PREPARED FOR THE PLAN COMMISSION

**Project Address:** 1406 Mound Street, 116 and 120 South Randall Avenue  
**Application Type:** Demolition and Conditional Use  
**Legistar File ID #:** [33076](#)  
**Prepared By:** Heather Stouder, AICP, Planning Division  
Report Includes Comments from other City Agencies, as noted

**East Elevation, Original Submittal** (brick base and limestone element in center of facade, matching existing building materials)

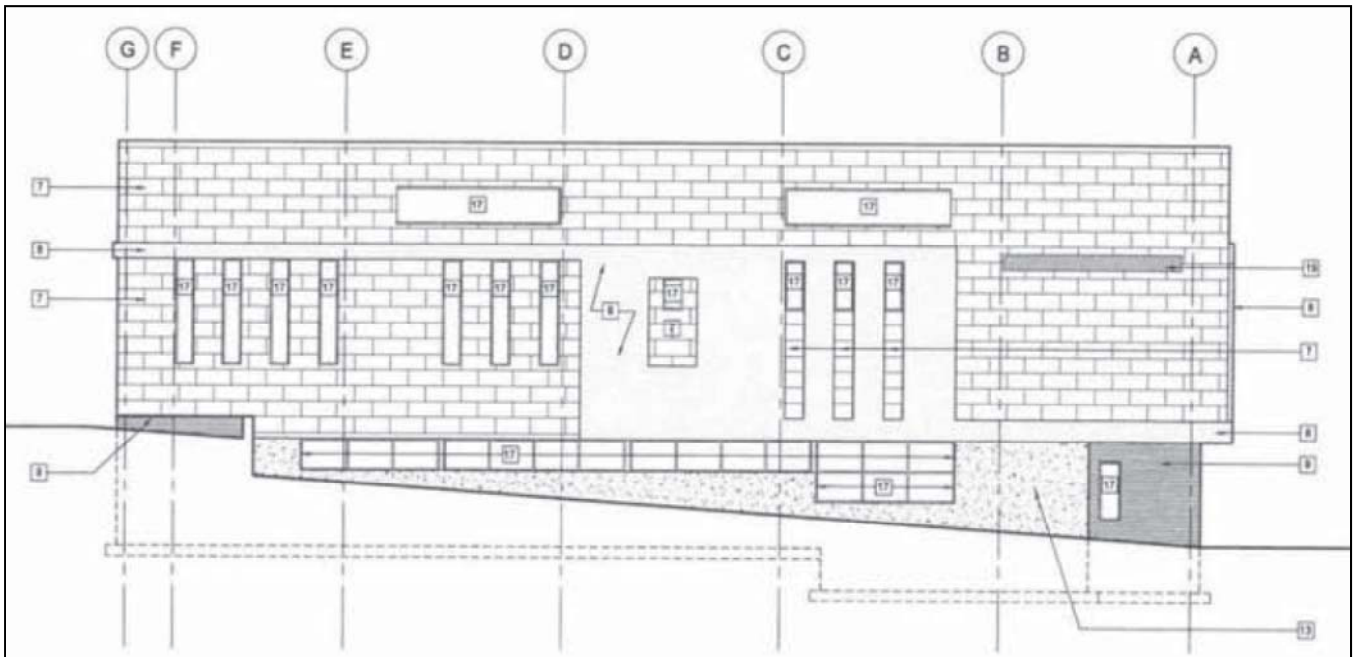
Staff believes that this standard can be met, but recommends that the applicant return to the originally proposed palette of materials (brick base and limestone accent wall) on the east side of the building, consistent with the materials on the rest of the building. Staff believes that the continuity of the brick base is especially important as a way to tie the primarily metal addition to the rest of the building. Otherwise, along South Randall Avenue, the primarily metal addition would maintain little continuity with the existing building. Staff understands that the applicant opposes this recommendation due to cost and other implications to the project.

1. Final plans submitted for staff review and approval shall include a detailed schedule of proposed materials, including color specifications. On the South Randall Avenue elevation, the applicant is encouraged to replace the proposed sandblasted concrete base with brick to match the rest of the building base, and also to replace the exterior plaster with limestone, as was originally proposed.
